Application for Waiver from Construction Standards for Public Water Systems

Water System Name: Portland Water Bureau	PWS ID:	00657	
Project or Facility: 6" DI Main in N Overlook Terrace	County:	Multnomah	
Need for waiver identified: Water System Survey Date of	of Survey:		
Plan Review # Exempt			
Construction standard requested to be waived: OAR 333-061-0050 (9)	9)(b) water se	ewer separation	
As provided under OAR 333-061-0055, OHA may grant waivers from the construction standards prescribed by these rules:

From 403'± SSL N Overlook Ter To 674'± SSL N Overlook Ter

6" DI Main

Plan Sheet

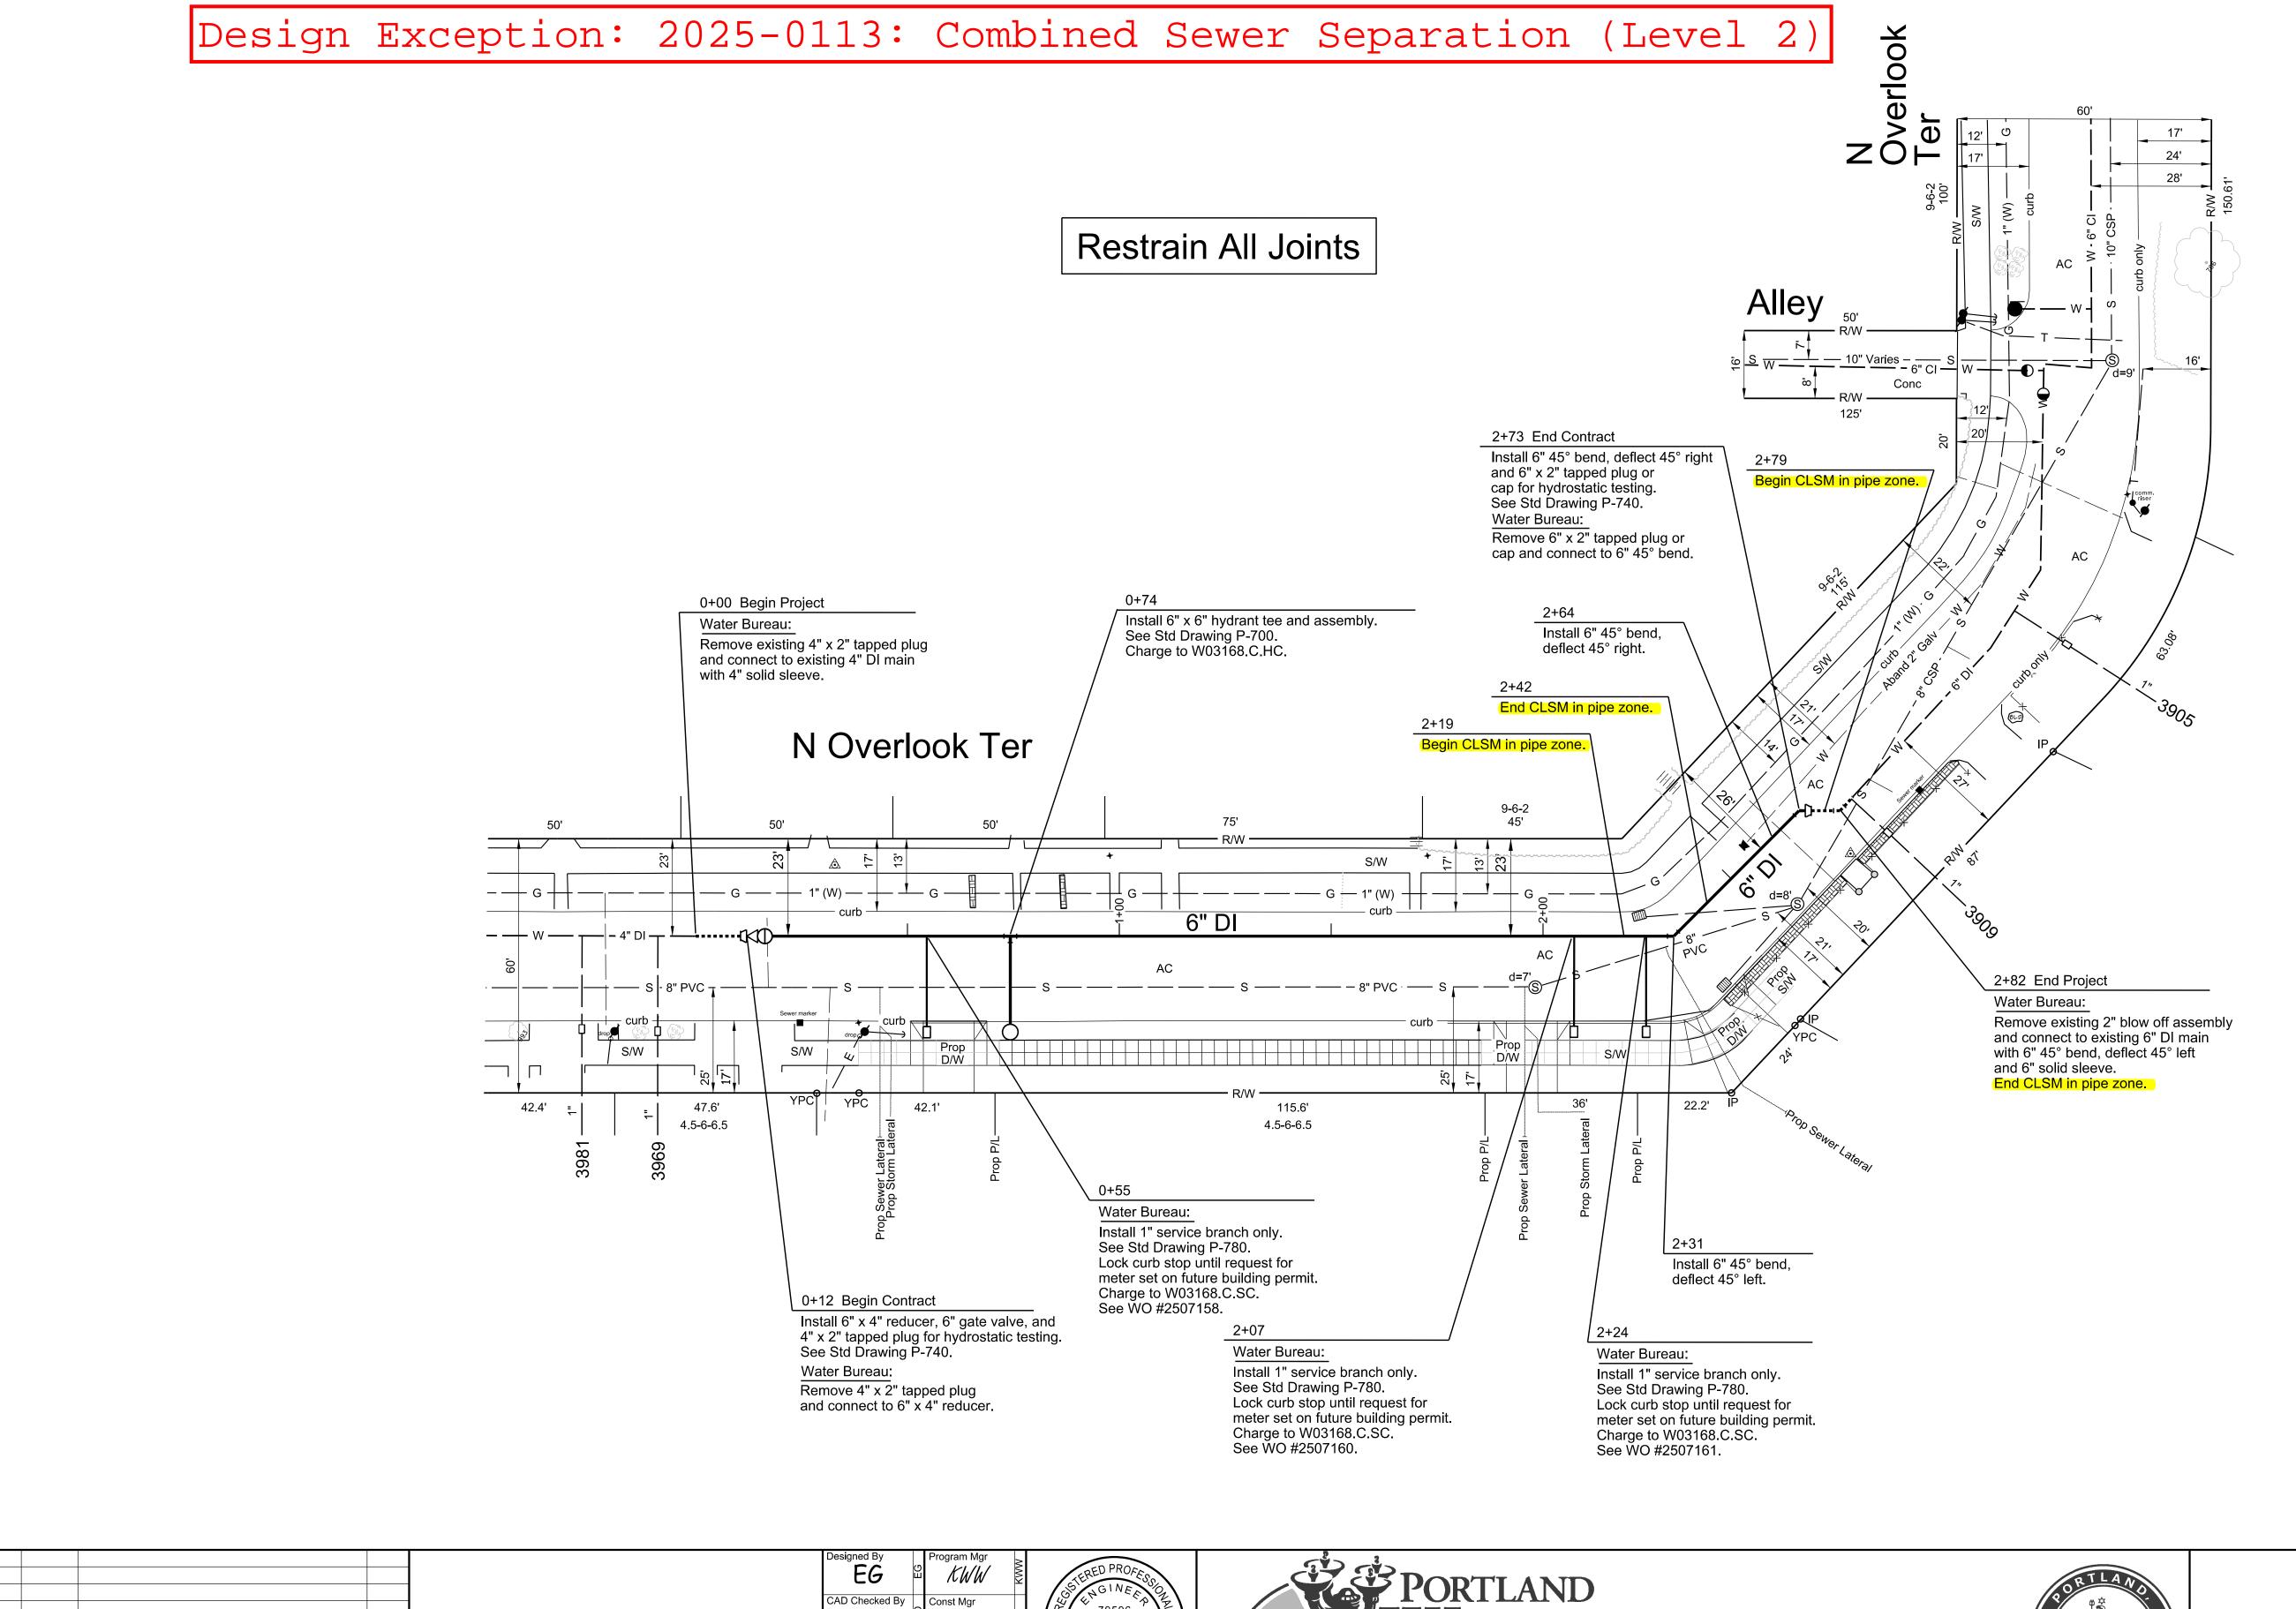
(c) When alternate measures are provided which, in the opinion of protection to the health and safety of the public including the adoes not exceed the maximum contaminant levels listed in rule.	ability to pro	duce water which	
Describe situation that conflicts with the standard. A proposed water	line comes w	vithin 5' parallel	
horizontal separation of an existing combined sewer at station 2+19 to 2+42 and at the tie in from			
station 2+79 to 2+82, creating a zone 2 conflict.			
Describe why meeting the standard is highly burdensome or impractical. The straight sewer does not			
leave room to maintain the standard horizontal separation as the roadway curves.			
Describe proposed alternate measure that provide adequate protection to public health and safety.			
The proposed water line will be encase in CLSM where it is within 5' of the existing sewer.			
EMAIL this form along with plans of proposed waiver request and additional supporting

Comments:	Organia ale Taur
Attachments (describe): Improvement plans for 6" DI Main in N	Overlook Terr
OHA Use Only	
Waiver ID: 554-2025	
Entered into waiver database	
✓ Plan Review Coordinator's notes: Proposed encasement with C the Zone 2 conflict.	LSM is an appropriate remedy fo
After due consideration the above requested waiver from the constru 061-0050 is hereby:	action standards of OAR 333-
Approved Comments:	
☐ Denied	
Kari Salis	9/5/2025
Technical Services Unit or Regional Manager OHA Drinking Water Services	Date
Waiver database updated
